Section 16 Planning Application for Proposed Temporary Public Vehicle Park (Private Cars Only) for a Period of 3 Years, Lots 1892 RP (Part), 1894 S.A (Part) and 1894 RP (Part) in D.D. 76, Leng Tsai Tsuen, Tai Kwu Ling, New Territories

1. Responses to Comments from Transport Department (TD)

2. Responses to Comments from Water Supplies Department (WSD)

Plan C: Proposed Layout Plan

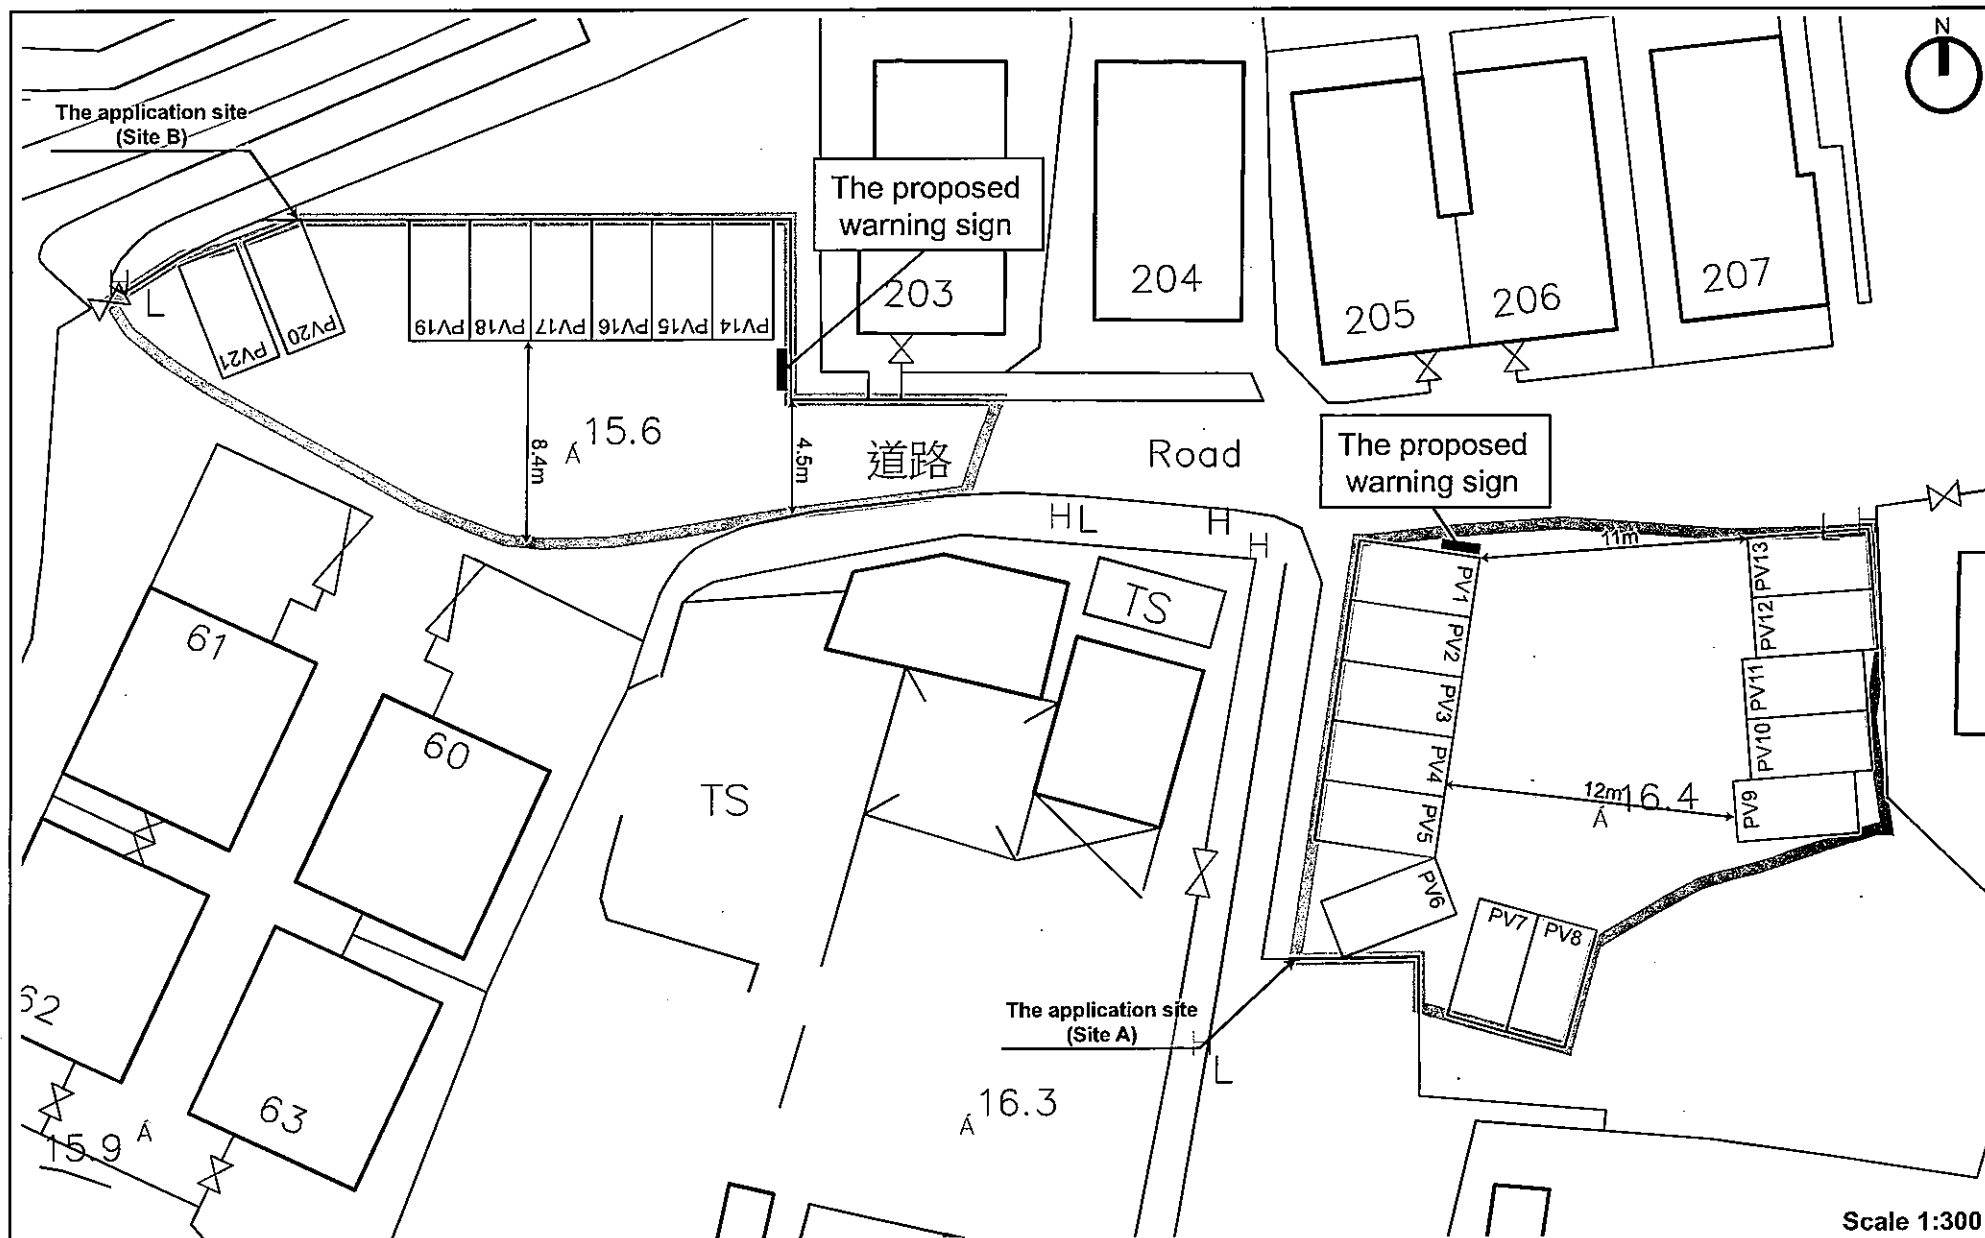
TD(2)	b. The applicant should clarify the dimensions of vehicle used in the swept path analysis;	The dimensions of vehicle used in the swept path analysis have been added on Plan D-1, Plan D-2 and Plan F.
TD(3)	c. The applicant should advise the location of the proposed warning sign and ensure that it will not clash with the path of movement of vehicles;	The location of the proposed warning sign has been indicated on the Plan C attached. The Applicant will ensure that the proposed warning sign will not clash with the path of movement of vehicles.
